Introduction

TV

VOLUME 2

Fig. 2 — Emerson

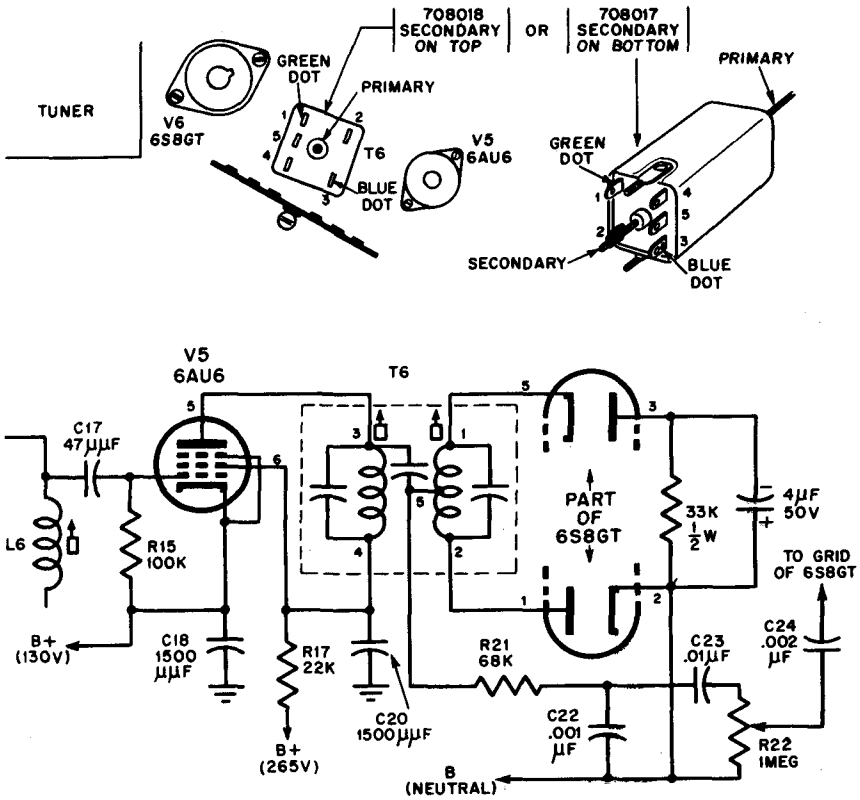
Remove following components from circuit:

2. Two 100-k (*R-19*, *R-20*) resistors from lug 5 of discriminator transformer (*T-6*).

3. *R-16*, *C-19* (8,200 ohms and 1,500 μmf) from pin 6 of *V-5* (6AU6).

5. Remove pigtail of *R-21* (68 k) going to pin 5 of 6S8 and connect to lug 5 of *T-6*.

6. Remove lead from pin 3 of *V-6* (6S8) and connect to pin 5 of *V-6*.

7. Add a jumper wire from lug 4 of *T-6* to pin 6 of *V-5* (6AU6).

9. Add a .001- μf , 400-volt capacitor from pin 6 of *V-6* (6S8) to B neutral.

13. Remove meter and adjust secondary (*T-6*) for maximum sound with minimum buzz.

Fig. 3 — Emerson

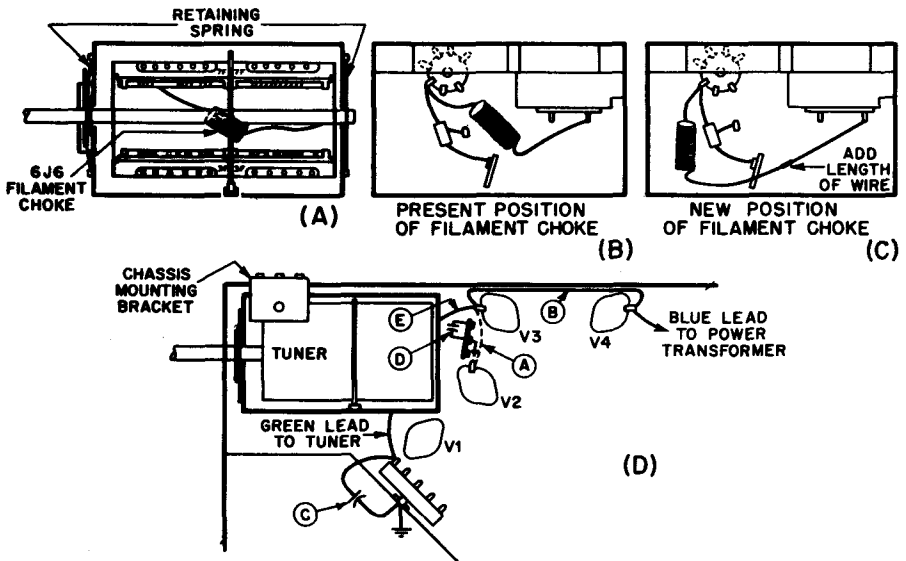
Break the cement which glues the 6J6 filament choke to the underside of the tuner chassis (see part (A) of figure) and dress away from chassis (towards turret). This can be accomplished by removing both sets of coils for channels 4, 5, 6, 11, 12, and 13, and then gently prying the choke loose with a screwdriver. Be careful not to damage or change the shape of the coil.

1. Remove turret from tuner by removing fibre shaft support, metal chassis mounting bracket, and the two turret retaining springs (located in front and rear of tuner chassis).

2. Reposition filament-choke coil as shown in part (C) of figure, making sure to keep choke and pigtails raised from chassis. This will necessitate the addition of an extra length of wire.

3. Refer to part (D) of figure in making changes listed below:

- a. Remove heater wire (shown dotted).

- b. Add new heater wire (keep off chassis).

- c. Add 1,500- μmf capacitor to bypass agc line.

d. Add 1,500- μmf capacitor to bypass tuner B+.

Fig. 4 - Emerson

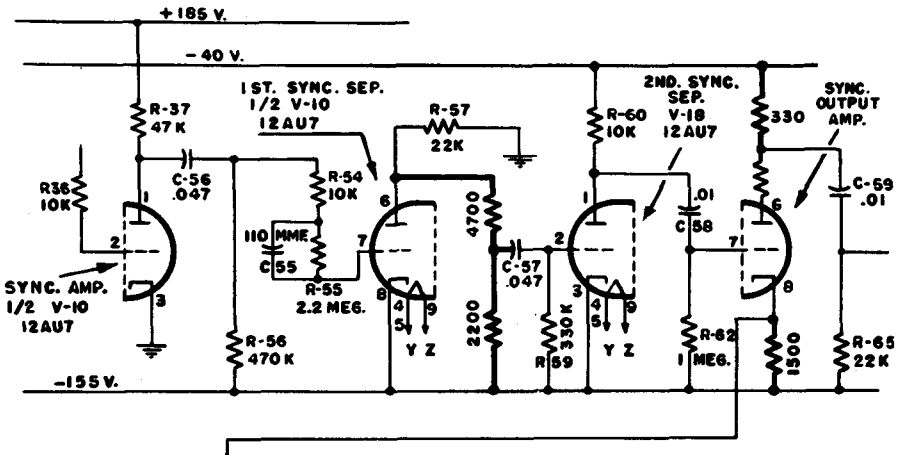
2. A 50- μmf , 4,000-volt capacitor is added from pin 3 of V-16 (6W4 damper tube) to junction of horizontal size coil, R-91 (750-ohm, 10-watt resistor) and wired to pin 1 of deflection yoke.

1. Remove R-58 (10 k, 1/2 watt), plate resistor of 1st sync separator.

3. Remove pigtail of C-57 (.05 μf) which went to pin 6 of V-10 and connect to junction of 4,700-ohm and 2,200-ohm resistors.

4. Change R-61 from 220 ohms to 330 ohms, 1/2 watt. This resistor is in the plate circuit of the sync-output amplifier.

Later production runs include these changes as shown in the figure.

Fig. 5 — Emerson

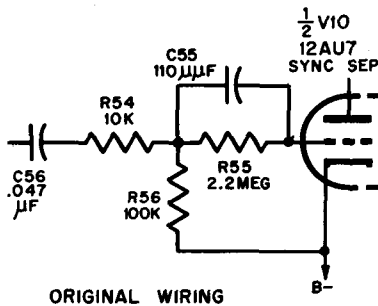
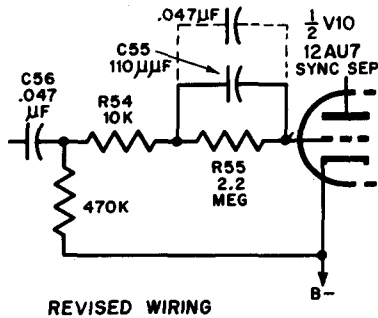
EMERSON Chassis 120129-B, -D,
 120140-B, -G, -H,
 120144-B, -G, -H
Improving sync stability in fringe areas (see Fig. 5).

The following changes should be made to improve sync stability in fringe areas. Chassis already incorporating this change have the letter *E* stamped inside the code triangle.

Change *R-56* from 100 k to 470 k, ½ watt, repositioning pigtail from junction of *R-54* (10 k), *R-55* (2.2 meg), *C-55* (110 μμf), to junction of *C-56* (.047 μf), *R-54* (10 k) as per figure.

In extreme fringe areas where little external noise is encountered, a .047-μf capacitor may be shunted across *C-55* as shown dashed in the figure.

Fig. 6 — Emerson

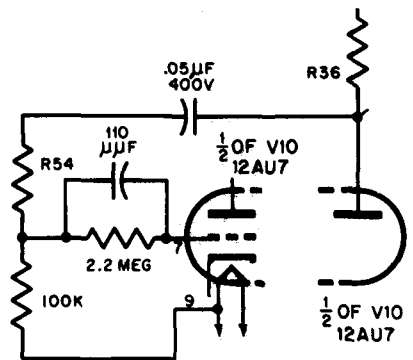
To improve the sync stability in extreme fringe areas, proceed as follows:

1. *R-36* (in plate circuit of sync amplifier) is changed from 10k ohms to 47k ohms.

4. A 2.2-meg resistor in parallel with a 110- $\mu\mu\text{f}$ capacitor is added between pin 7 of *V-10* and *R-54* (old junction of *C-55* and *R-55*).

5. A .05- μf , 400-volt capacitor is added between pin 1 of *V-10* and *R-54* (10k ohms).

6. A 100k-ohm, $\frac{1}{2}$ -watt resistor is added from pin 9 of *V-10* to junction of *R-54*, 2.2-meg resistor, and 110- $\mu\mu\text{f}$ capacitor.

The complete change should alter the schematic as shown in the figure. Some sets in later production runs already contain this circuit modification.

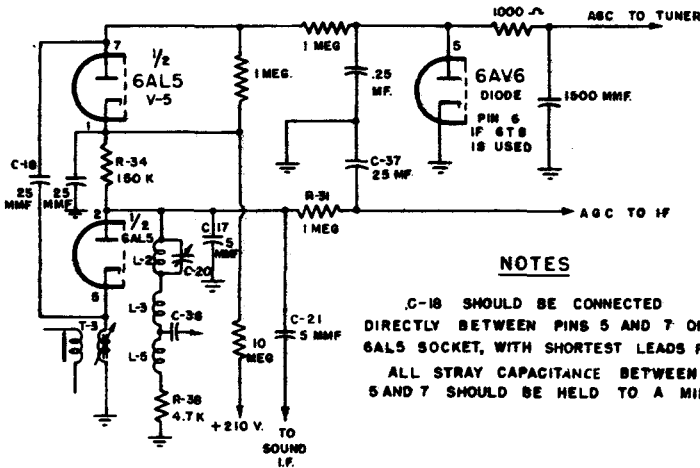
EMERSON Chassis 120129-B, -D
Modification of agc for fringe-area operation (see Fig. 7).

1. Omit R-35 (100 k, $\frac{1}{2}$ watt). This resistor is connected to plate of agc detector.
2. Change R-34 (in plate circuit of video detector) from 22 k to 150 k.
3. Add a 1-meg, $\frac{1}{2}$ -watt resistor from pin 1 to pin 7 of V-5.
4. Remove pigtail of C-18 (25 μ f) from pin 1 of V-5 (6AL5) and connect to pin 7. Note: Wire directly to tube socket keeping stray capacitance and lead lengths to a minimum.
5. Add a 25- μ f ceramic capacitor from pin 1 of V-5 to chassis.
6. Move pigtail of R-31 (1 meg, $\frac{1}{2}$ watt) from pin 7 of V-5 to pin 2 of V-5.
7. Add a 10-meg, $\frac{1}{2}$ -watt resistor from pin 1 of V-5 to B+ 210 volts (C-51 square marking).

8. Change terminal strip near sound-output transformer from 3-lug to 5-lug strip.

9. Add a wire from pin 5 of 6AV6 to empty lug on new strip. If set uses a 6T8 use pin 6.

11. Add a 1-k, $\frac{1}{2}$ -watt resistor between junction of added .25- μ f, 200-volt capacitor and lead to 6AV6 and additional empty lug on new strip.

12. Add a wire from this new point to tuner agc on terminal board near tuner.

13. Remove R-3 (1,000 ohms, $\frac{1}{2}$ watt) from agc line.

14. Add a 1-meg, $\frac{1}{2}$ -watt resistor from pin 7 of V-5 (6AL5) to pin 5 of 6AV6 (see step 9).

Fig. 9 — Emerson

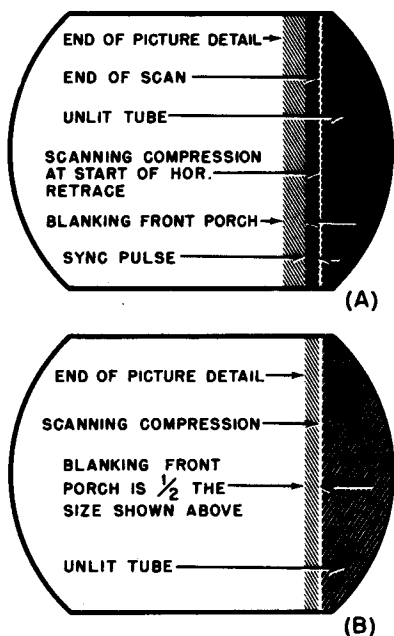
1. Replace *R-75* (220 k in afc feedback circuit) with two 100-k, $\frac{1}{2}$ -watt resistors in series.

2. Connect a 25- $\mu\mu\text{f}$ ceramic capacitor from the junction of the two

100-k resistors to chassis, dressing the components away from the horizontal-phase and frequency coils.

g. Decrease contrast and turn up brightness while viewing a nicely received picture so that front horizontal blanking porch is visible (see part (A) of figure) on right hand side of picture.

h. Remove short across phasing coil and adjust until start of the horizontal-sync pulse is visible which is slightly blacker than the front porch.

Fig. 10 — Emerson

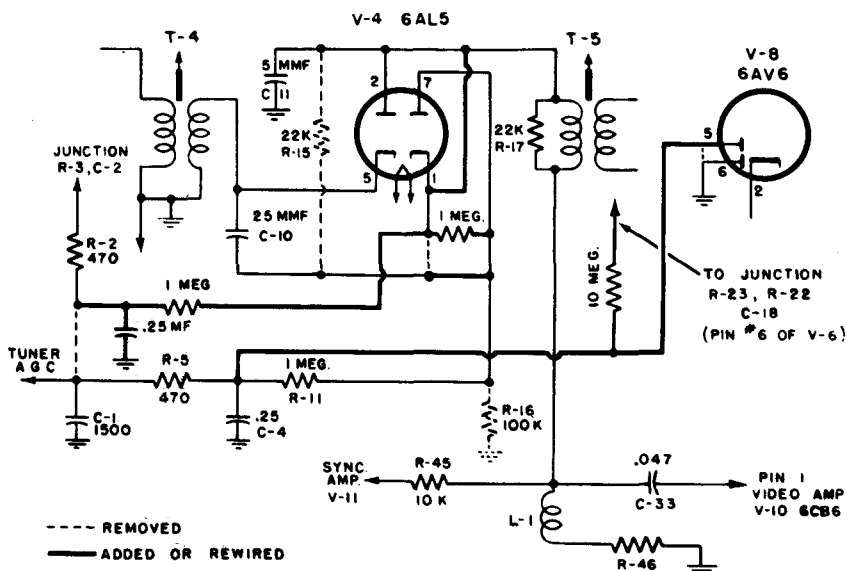
Modified agc for fringe-area operation (see Fig. 10).

The following changes may be made to improve performance, especially in fringe areas, by modifying the agc system to give a tuner delay. This modification will provide an increase in sensitivity.

1. Remove *R-15* (22k, $1/2$ watt) from pins 1 and 2 of *V-4* (6AL5), replacing it with a jumper wire.
2. Remove *R-16*, 100 k, which is connected from pin 7 of *V-4* to chassis.
3. Remove pigtail of *R-2* (470 ohms) resistor from lug on terminal board and reconnect to empty lug on same terminal strip. This resistor is in the grid circuit of *V-1*.
4. Add a white jumper wire from new position of *R-2* to the empty lug

on the terminal board near sound-output transformer.

5. Add a 1-meg, $\frac{1}{2}$ -watt resistor from this empty lug near audio-output transformer to pin 7 of *V-4*.

6. Add a .25- μ f, 400-volt capacitor from above point on terminal strip to chassis.

7. Remove pigtail of *C-10* (25 μ f) from pin 1 of *V-4* and connect to pin 7 of *V-4*.

8. Add a 1-meg, $\frac{1}{2}$ -watt resistor from pin 1 to pin 7 of *V-4* (6AL5).

9. Remove all ground connections from pin 5 of *V-8* connecting center shield pin to pin 6, if not already there.

Note: Due to agc change the following resistance measurements change appreciably. *V-4* pin 1, 4.7 k; pin 7, 900 k. *V-8* pin 5 changed to 1.8 meg.

Fig. 12 — Emerson

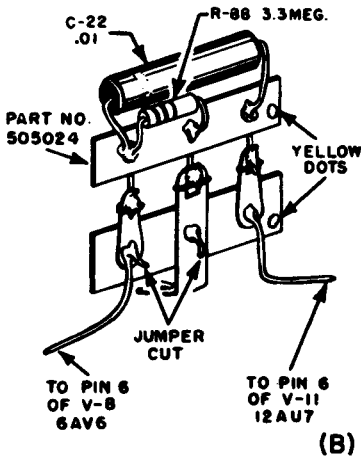
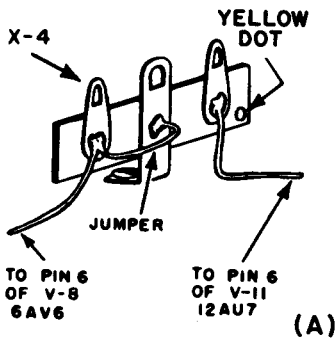
2. Clip jumper wire as shown in part (A) of figure.

3. Add part No. 505024 as shown in part (B), making sure yellow dots are lined up and leads are properly soldered.

Fig. 15 — Fada

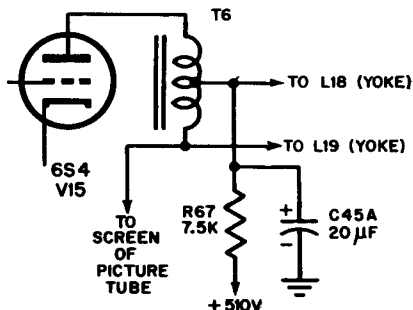
1. Disconnect screen (pin 10) of picture tube from junction of C-57 and C-58, and reconnect to junction of

L-19 of the yoke and the B+ terminal of *T-6*.

2. Reconnect the B+ input to the vertical-output stage, to the tap on *T-6* as shown in the figure.

Fig. 16 - Fada

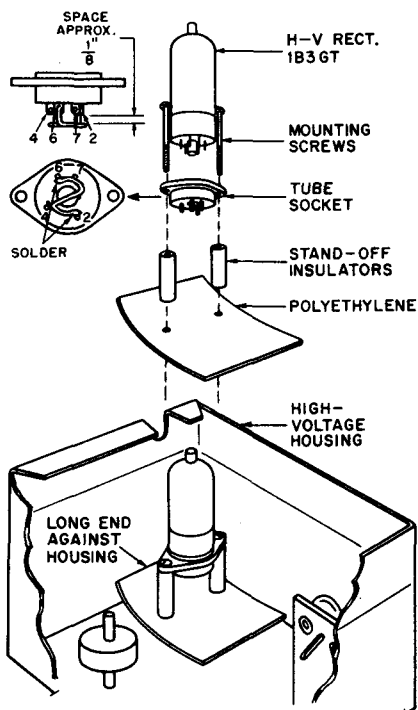
Remove the 1B3 socket assembly from the chassis by removing the two screws that mount the socket assembly on the chassis. Remove the 1B3 tube from its socket and turn the socket over. The socket should be checked for lint, spider webs, and sharp wire or solder points.

Place the plastic insulator strip on the chassis with the long end toward the h-v cage as shown on the sketch. When the socket assembly is remounted, care should be taken that the filament link and leads are kept as far away as possible from the main coil of the horizontal-output transformer, since otherwise corona may result between these two points.

In areas of high humidity an additional change may be necessary if corona still exists under the 1B3 socket. The one megohm resistor mounted on the socket should be replaced with an S-shaped corona ring, constructed of heavy solid wire. The corona ring should be mounted so that all the lugs of the socket are in line with the corona ring, as shown on the attached sketch. In most cases the corona ring will not be necessary; it should be used only when required.

Fig. 20 — General Electric

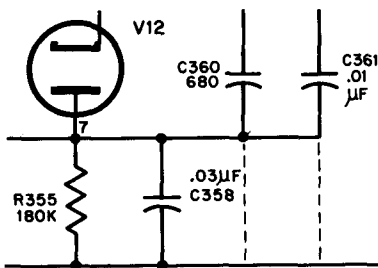
Curl at top of picture (see Fig. 20).

A few receivers have shown a slight displacement (to the right) of the first few horizontal scan lines which shows up as a slight curl at the top of the picture. This trouble is caused by a delay in recovery of the horizontal afc circuit after the occurrence of each vertical sync pulse, and is compensated for by feeding a correction voltage of proper magnitude and phase into the afc circuit. The circuit revision is shown in the sketch; the procedure follows:

Fig. 22 — General Electric

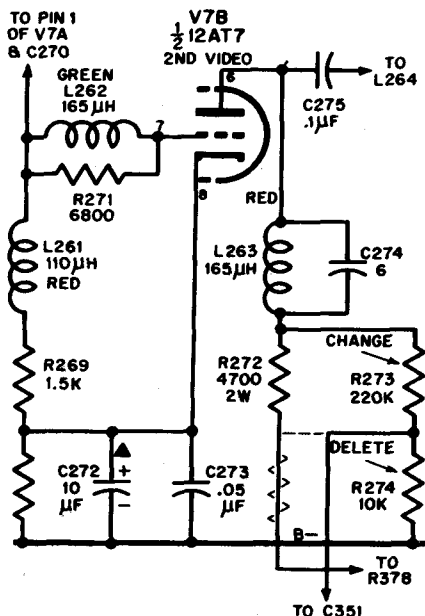
Correcting bending at top of picture (see Fig. 22).

In early production receivers R-273, R-274 and the sync voltage take-off capacitor C-351 were connected as shown in the figure. To correct bending at the top of the picture R-274 is deleted. R-273 is changed to 220 ohms and is reconnected in series with R-272. C-351, the sync-coupling capacitor, is now connected at the junction of R-272 and R-273 as shown in the dashed lines.

Fig. 23 – General Electric

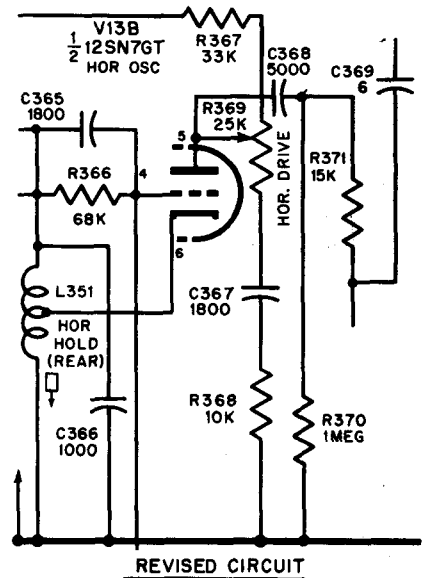
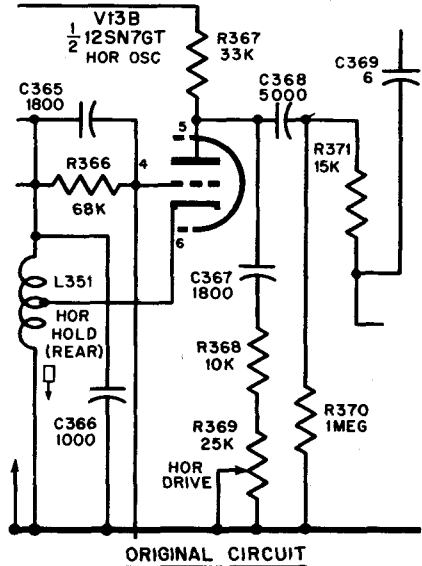
To eliminate vertical bounce of the picture (vertical shift) at certain settings of the picture control which may be noted when a change in studio cameras takes place, change the plate-coupling circuit of V-11 as follows. R-353 is changed to 470,000 ohms and C-353 is changed to 470 μ f. Late production models incorporate this change.

Fig. 25 — General Electric

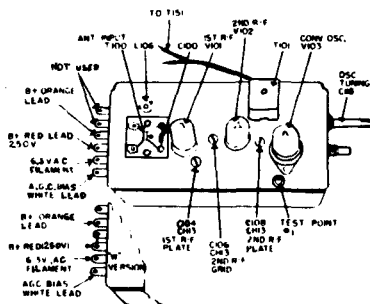
F-M interference reduction in tuner (see Fig. 25).

In order to reduce f-m interference the resistance *R-103*, (3,300 ohms, 1/2 watt) in the tuner is increased to a value of 5,600 ohms, 1 watt, part No. URE-067. The r-f tuner with this new resistor is stamped "W" for easy identification. To compensate for the higher voltage drop the B+ to the tube *V-101* is increased from 160 to 250 volts. This is accomplished by moving the orange wire (B+ 160 volt) to the second lug from the top (see figure) and connecting the third lug with the fourth lug which connects the B+ for *V-102* to the B+ 250-volt red lead.

Fig. 26 — General Electric

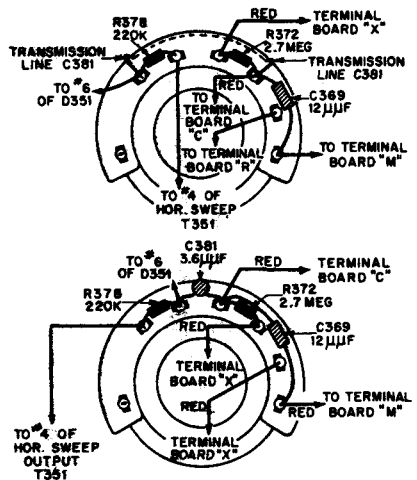
Improved deflection-yoke installation (see Fig. 26).

The early production yoke RLD-030 which is identified by the markings on the yoke as follows "M77J11-10- #33, blue code dot on the winding tape" is replaced by the yoke RLD-037. The use of this improved yoke necessitates the installation of a variable trimmer, *C-302*, RCY-069 (1 to 12 mmf). The trimmer is connected to the yoke terminal 8 and chassis ground. A lead is already provided on the yoke for this purpose.

Fig. 27 - General Electric

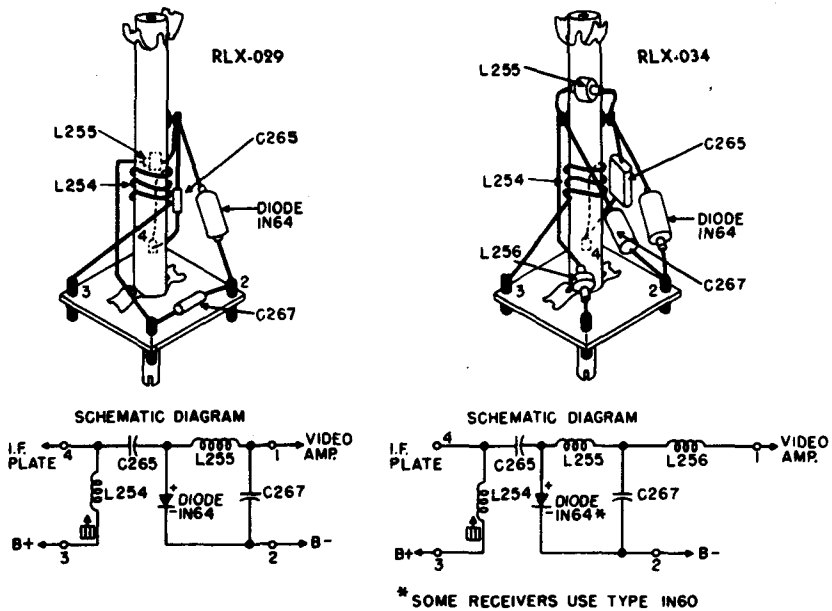
In some assemblies a special high efficiency diode is used, marked with a red dot. To maintain the same Q of the circuit and to obtain proper i-f bandwidth a resistor of 12,000

ohms in connected across the diode. In replacing this diode with normal stock do not use this resistor. In case of doubt check for proper bandwidth.

Fig. 28 - General Electric

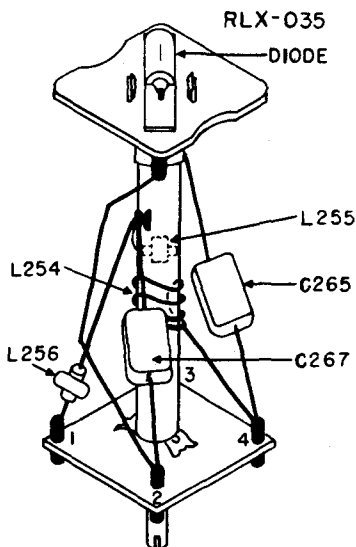
In order to improve horizontal linearity, capacitor C-373 in horizontal-linearity circuit is changed from

a value of .1 μ f to 0.06 μ f (part No. UCC-046). At the same time the cathode (pin 8) of horizontal-output tube *V-14*, 25BQ6, is connected directly to ground, removing *R-381* and *C-381*. In late production receivers ion trap RET-003 was replaced by a cunifering, type RET-012, to further improve horizontal linearity.

Fig. 29 — General Electric

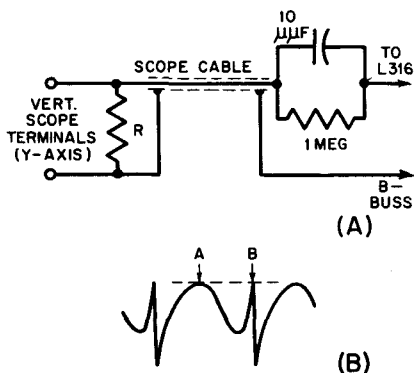
(see Fig. 29).

On the above production receivers, a tuned circuit is added to the horizontal blocking oscillator circuit to stabilize the sync. The method des-

Fig. 37 — Hoffman

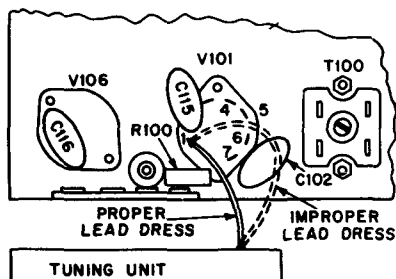
Channel-11 picture interference
(see Fig. 37).

Fig. 42 — Hoffman

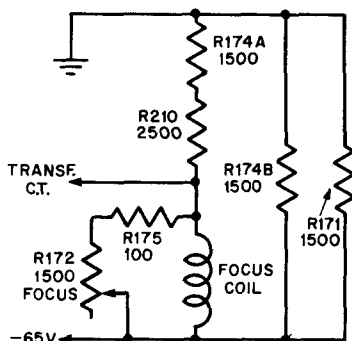
Circuit changes to increase the amount of current through the focus coil can be accomplished by changing one resistor and adding another resistor, as shown in the accompanying diagram.

Fig. 43 — Hoffman

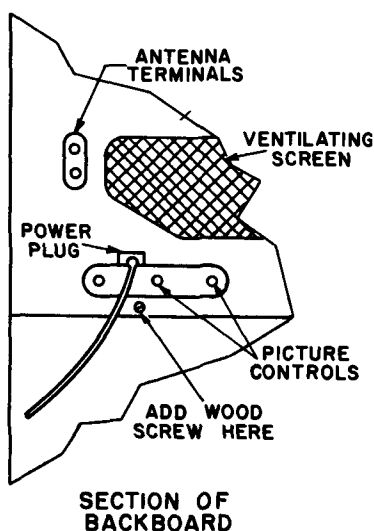
HOFFMAN Chassis 146
Power-cord interlock looseness (see Fig. 43).

Fig. 45 — Hoffman

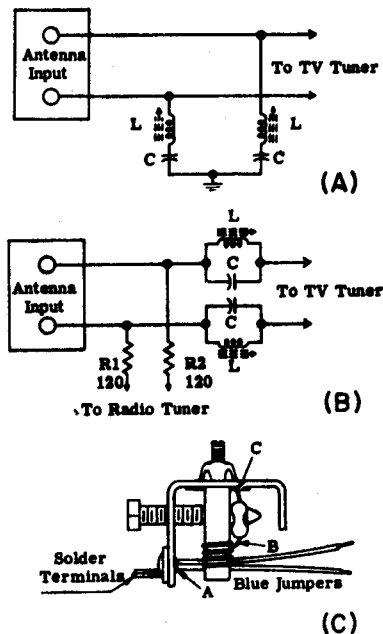
Interference trap for channel 2 (see
Fig. 45).

Fig. 47 — Hoffman

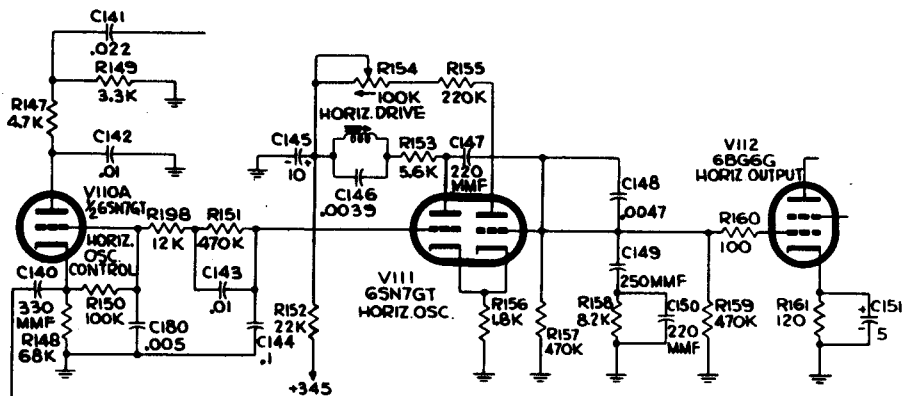
The hook can be materially decreased by addition of a 12k-ohm, 20%, 1/2-watt, composition resistor (*R-198*) and a .005- μ f ceramic capacitor (*C-180*) in the grid circuit of the horizontal oscillator control tube, *V-110A*. Refer to the schematic diagram shown here for location of these components. A further change which will improve the hook is the change of *C-142* from a .0047- μ f to a .01- μ f, 400-v paper type capacitor. However, this change reduces the horizontal sync hold-in range, and it is imperative that *C-146* and *C-149* be changed

Fig. 50 — Hoffman

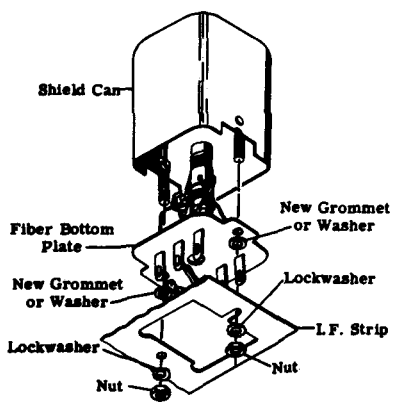
Mounting modification of 3rd i-f transformer shield (see Fig. 50).

Fig. 51 — Hoffman

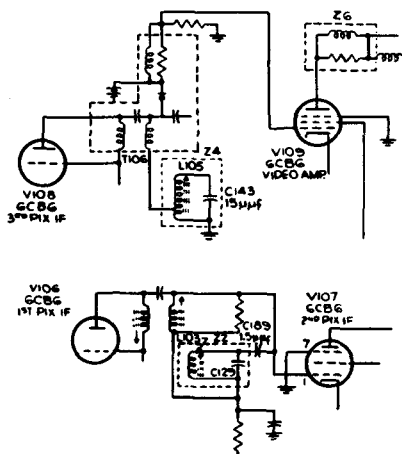
Removing 4.5-mc beat interference (see Fig. 51).

Fig. 58 — Hoffman

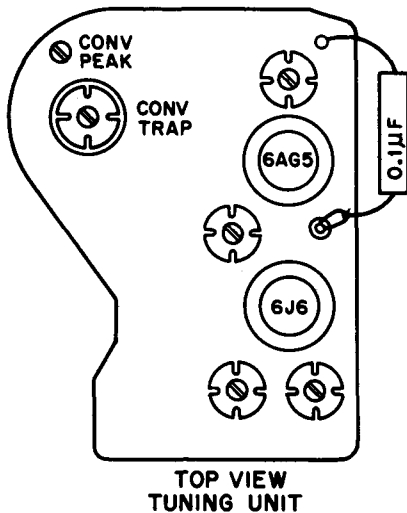
HOFFMAN Chassis with turret tuners RF-3 through RF-6
Tunable modulation hum (see Fig. 58).

Fig. 59 — Hoffman

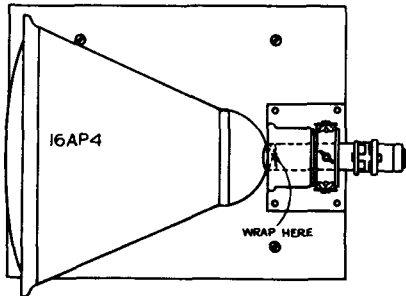
HOFFMAN Chassis with
16-inch metal picture tubes
**High-voltage arcing around
picture-tube neck (see Fig. 59).**
